SUBJECT: WATERFORD STEAM ELECTRIC STATION, UNIT 3 – SUMMARY OF  
CONFERENCE CALL REGARDING THE SPRING 2014 STEAM GENERATOR  
TUBE INSPECTIONS (TAC NO. MF3888)

**CONFERENCE CALL SUMMARY REGARDING SPRING 2014  
STEAM GENERATOR TUBE INSPECTION ACTIVITIES**

## **STEAM GENERATOR TUBE INSPECTION DISCUSSION DURING WATERFORD 3's 2014 (1R19) OUTAGE**

### Waterford 3 Primary to Secondary Leakrate based on Tritium for Cycle 19

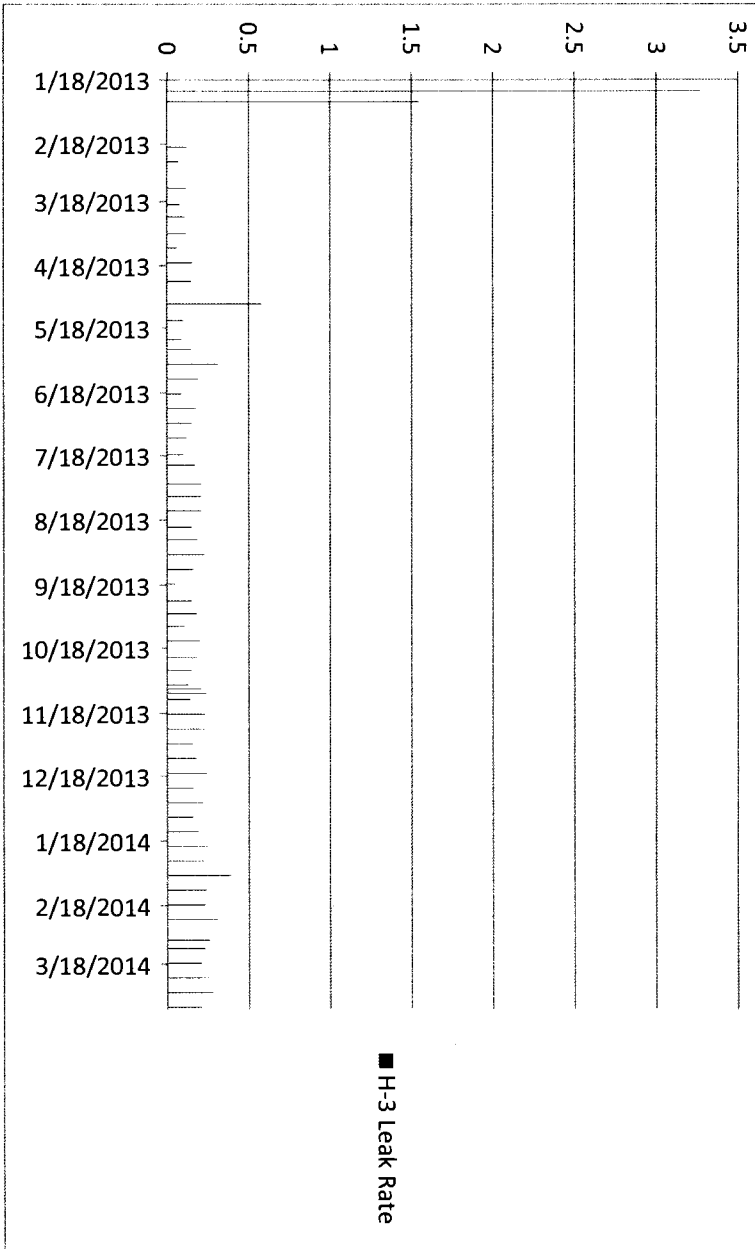
- This is the first SG inspection following installation of replacement SGs in the fall of 2012.
- In the Primary to Secondary Leakrate graph on page 6 of Enclosure 2, the y-axis units are gallons per day (gpd). Because there was no detectable gamma radiation associated with the tritium leak rate, the licensee concluded there was no primary-to-secondary leakage.
